**PLANNED UNIT DEVELOPMENT
& SUBDIVISION STAFF REPORT****Date: November 5, 2015****DEVELOPMENT NAME**

Fullbrook Center Subdivision

Planned Unit Development Approval to allow shared
access and parking on multiple building sites and Subdivision Approval to create 4 legal lots of
record from several existing metes and bounds parcels.

SITE PLAN

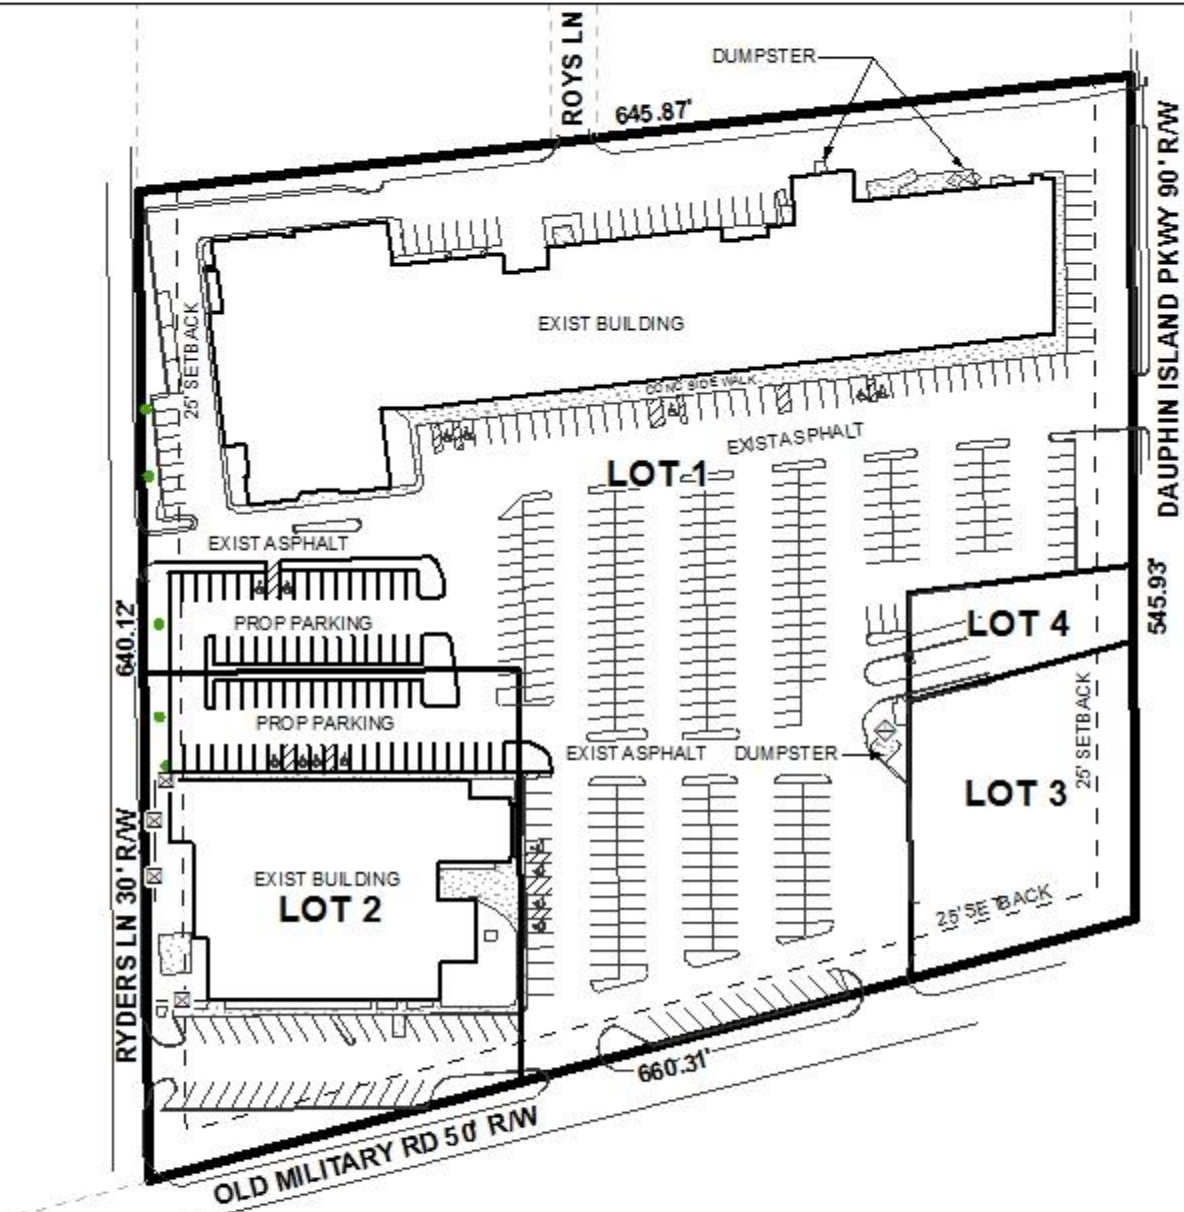
All proposed parking areas appear to be compliant in terms of travel aisle width and parking stall dimensions; however, the proposed parking spaces adjacent to the northern side of the existing commercial building on the proposed Lot 2 do not appear to contain any bumper stops, and it is unclear if curbing is provided. Any revised site plan or building plan should comply with Section 64-6. of the Zoning Ordinance, in addition to design compliance with the accessibility requirements of the applicable building code section at the time of permitting. It should be pointed out that staff was not provided an existing / proposed tenant mix of the existing buildings and, therefore, overall parking calculations cannot be verified at this time.

In addition, the site plan should be revised to illustrate compliance with Section 64-6.A.3.i. of the Zoning Ordinance regarding screening and landscaping requirements to ensure proposed parking facilities are appropriately screened from adjacent residentially used property. Generally, a 3' – 5' tall evergreen hedge may be appropriate. All required buffering along Ryders Lane should be depicted on the revised site plan.

Tree and landscaping information for the overall site is not depicted on the site plan but existing trees 24" and larger are illustrated. As no significant structural expansions are proposed at this time, full compliance with the tree and landscaping requirements of the Zoning Ordinance will not be required at this time; however the provision of three understory parking trees will be required as a result of the proposed parking spaces and should be depicted on the revised site plan.

There is no dumpster depicted on the proposed Lot 2, which would suggest waste removal will be via curb-side pick-up. As such, any revised site plan should illustrate the location of a dumpster in compliance with Section 64-4.D.9. of the Zoning Ordinance, or a note stating that waste removal will be via curb-side pick-up.

It should be pointed out that although no changes are anticipated for the proposed Lots 3 and 4, these lots should be detailed as they are a part of the Planned Unit Development. Sidewalks, the existing commercial buildings, parking facilities, sign structures, landscaping and so forth, should all be illustrated on the revised site plan.

- 1) Submission of a tenant mix of the overall site in order for staff to determine parking compliance;
- 2) Revision of the site plan to illustrate dedication along Dauphin Island Parkway and Ryders Lane, and a corner radius at the corners of Ryders Lane and Old Military Road and Old Military Road and Dauphin Island Parkway, in coordination with the Final Plat;

- 3) Revision of the lot size information and 25' minimum setback lines on the site plan to reflect dedication, in coordination with the Final Plat;
- 4) Revision of the site plan to illustrate curbing and / or bumper stops for all proposed parking spaces along the northern side of the existing commercial building on Lot 2;

- 5) Revision of the site plan to illustrate all existing development on Lots 3 and 4;
- 6) Depiction of all sidewalks, signage and dumpsters on the site plan, along with a note stating compliance with Section 64-4.D.9. of the Zoning Ordinance regarding dumpster compliance;

- 7) Provision of landscaping notes, 3 understory parking trees for the proposed parking facilities and retention of all depicted trees larger than 24";

- 8) Revision of the site plan to depict a dumpster in compliance with Section 64-4.D.9. of the Zoning Ordinance for Lot 2, or a note stating that waste removal will be via curb-side pick-up;
